RE: Pennsylvania Gaming Control Board
Sugarhouse Casino TIS Review
PennDOT Agreement E00229, Work Order 14
EK Project No. 040015.038

In accordance with Agreement E00229, Work Order 14, Edwards and Kelcey has completed its detailed review of the Sugarhouse Traffic Impact Studies (TIS), prepared by Gannett Fleming dated December 2005 and October 13, 2006. Our review considered the applicant's completeness in meeting the standards set forth by PennDOT and the Institute of Transportation Engineers (ITE), as well as the completeness and reasonableness of their assumptions, calculations, findings, and conclusions.

Figure 2: Penn Street and Delaware Avenue

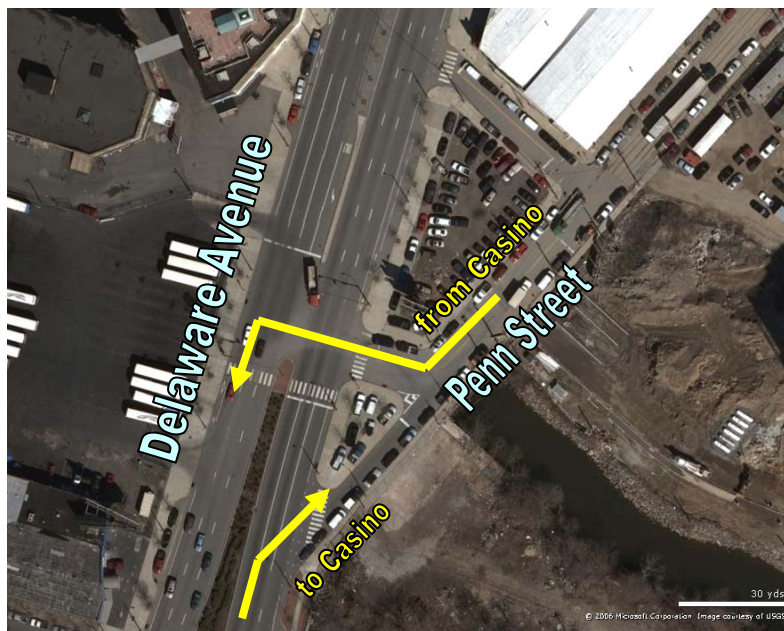
8. The intersection of Delaware Avenue and Penn Street was included in the analysis, because bus and truck traffic will use Penn Street to access the casino. It was planned for all bus and truck traffic to arrive outside of the peak hour, thereby minimizing the casino's impact on local traffic during the busiest time of day. This restriction of bus/truck traffic is a good idea from a planning perspective, however, with no truck/bus traffic during the design hour, there is no analysis of the impacts of trucks/buses at the intersection of Penn Street entrance and Delaware Avenue.

Parking is permitted on both sides of Penn Street, and the roadway appears somewhat narrow. The intersection geometry should be evaluated with respect to truck and bus turning movements.

The distribution figures show zero traffic using the Penn Street access. However, the Traffic Volume Diagrams show some volume on Penn Street attributed to the casino. Also, it is likely that some car-trips will use the Penn Street entrance, particularly employees or others familiar with the site and coming from the south. Some percentage of car traffic should be distributed to this entrance in addition to the truck/bus traffic. It is not clear whether the analysis included car trips and/or truck/bus trips at the Penn Street/Delaware Avenue intersection.

Under existing conditions, the intersection of Delaware Avenue and Penn Street was reported to experience LOS E during the PM Peak hour on the Penn Street approach. Using the same volumes but different signal timings, the LOS under existing conditions for that approach in the revised report is listed as LOS C. Discussion of this difference should be presented. Figure 2 shows a photo of the intersection.
